SUBJECT: Forwards Rev 28 to "Radiological Emergency Plan."
 Attachment 1 provides summary of plant radiological
 emergency plan Rev 28 changes.

Re: Turkey Point Units 3 and 4
Docket Nos. 50-250 and 50-251
Radiological Emergency Plan - Revision 28

SUMMARY OF TURKEY POINT RADIOLOGICAL EMERGENCY PLAN - REVISION 28 CHANGES

TURKEY POINT RADIOLOGICAL EMERGENCY PLAN - REVISION 28

FIGURE 1-1

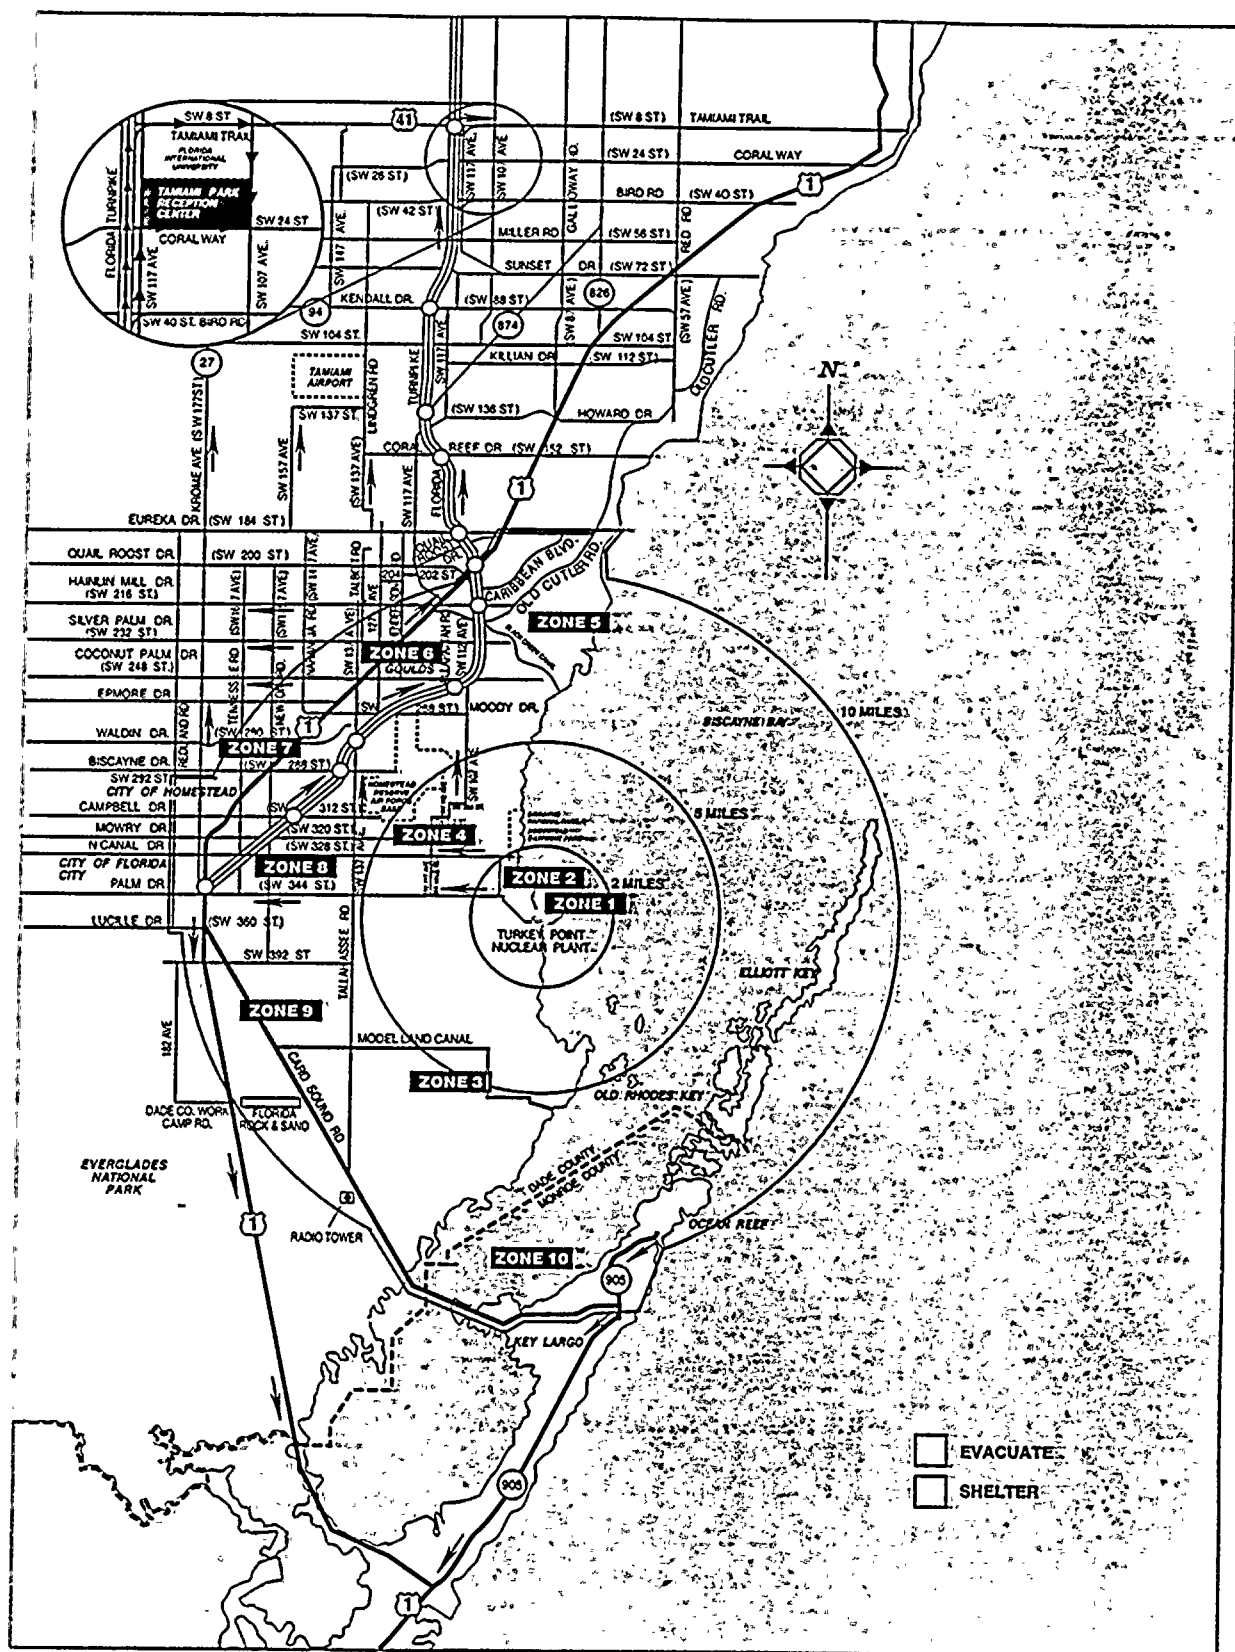
<u>Section</u>	<u>Page</u>	
1.2	1-3	Changed word... "activate" to " <u>implement</u> the appropriate sections of the Emergency Plan."
1.2	1-5	Changed definitions for "Thyroid Dose" (CDE) and "Total Dose" (TEDE).
Fig 1-1	1-7	Remove shading and add bold lines to Emergency Planning Zones.
Fig 1-2	1-12	Remove box for "System Operation Power Coordinator (SOPC)". This was originally as a backup method of notification for the Nuclear Division Duty Officer (NDDO). There are now several other options for making this notification. The NDDO Schedule list several methods of contact including call forwarding from the NDDO designated company phone, cellular phone and alpha/numeric paging. Additionally any other qualified NDDO can act as a backup.
Fig 2-1	2-2	Changed Security Shift Supervisor to "Security Specialist," title change by Security.

FIGURE 5-1

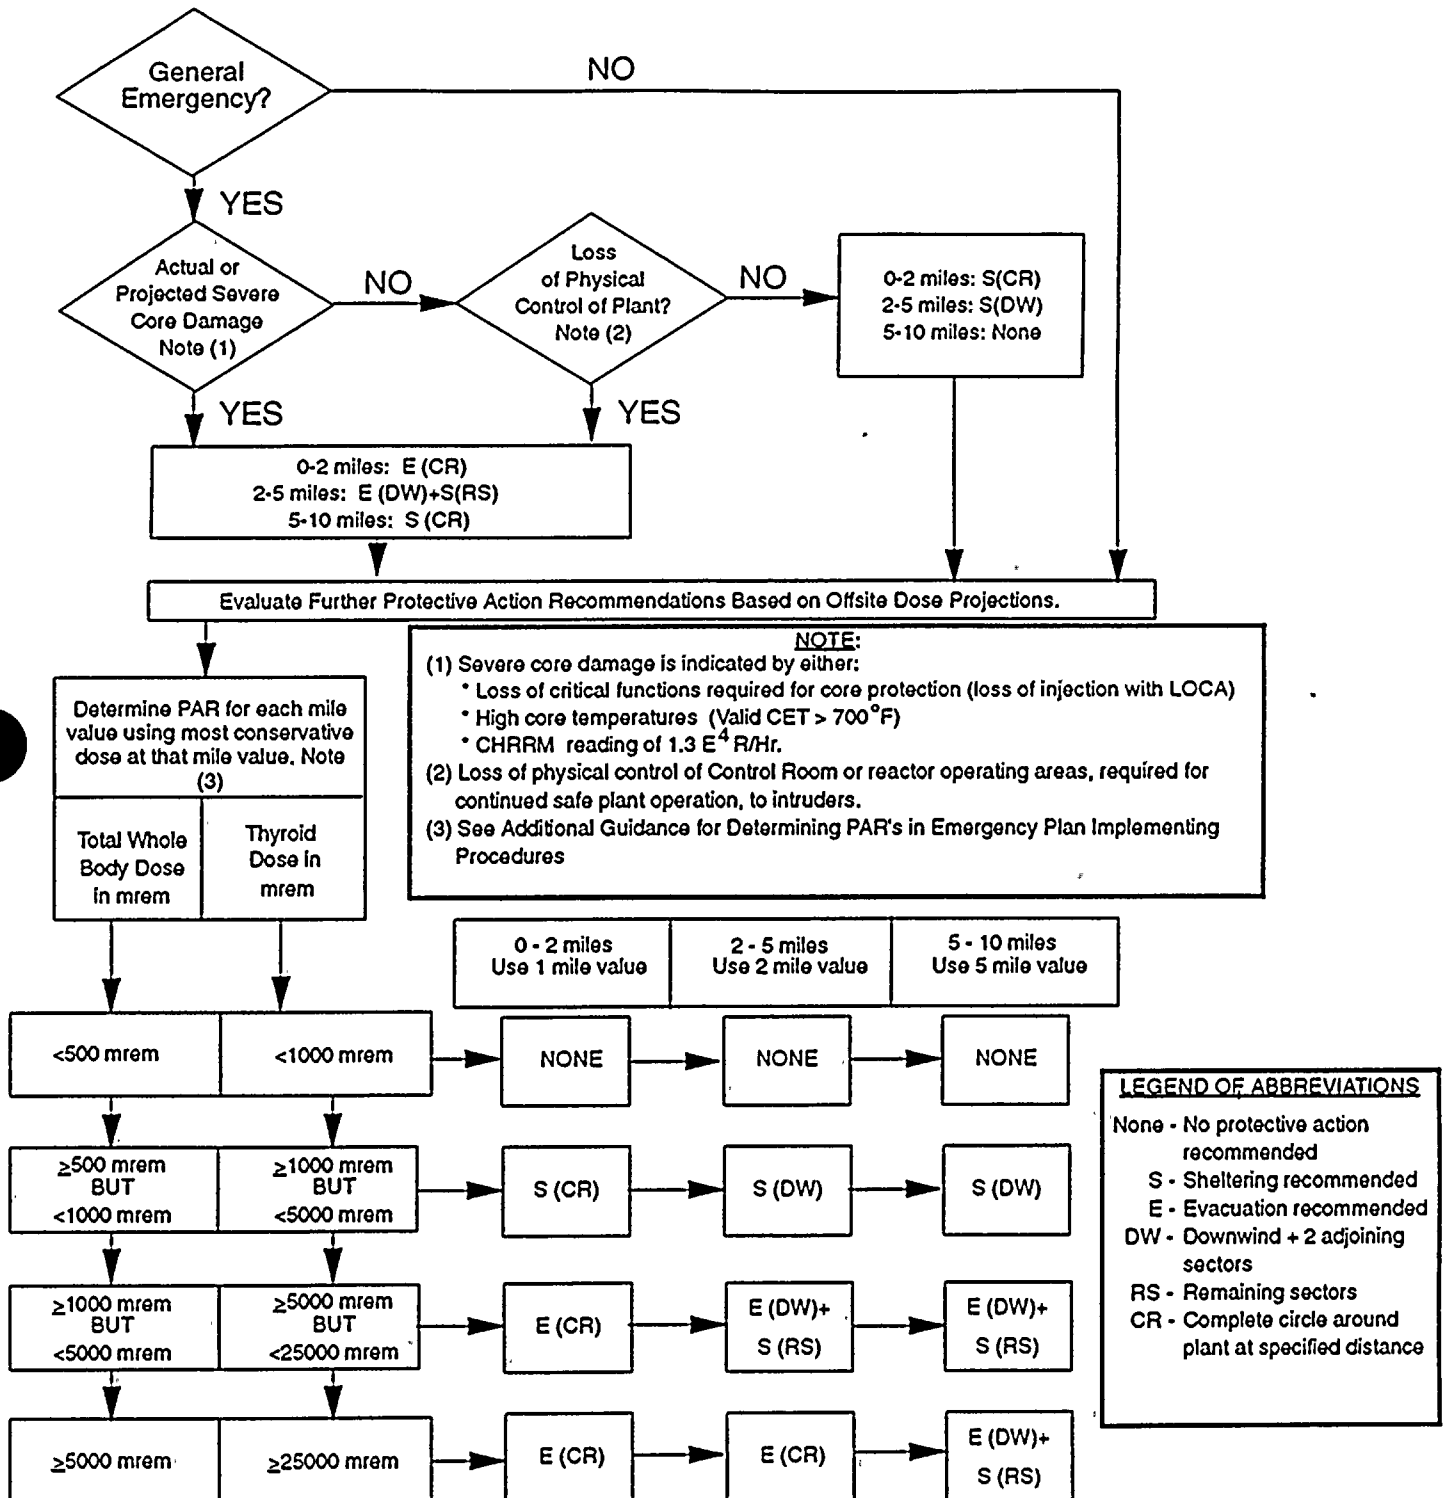
<u>Section</u>	<u>Page</u>	
5.1.3	5-3	Changed National Weather Service "at Miami International Airport" to "in Miami" to reflect correct location.
Fig 5-1	5-8	Protective Action Recommendation Table: Change "Total Whole Body Dose" to "Total Dose (TEDE)" and change "Thyroid Dose" to "Thyroid Dose (CDE)".
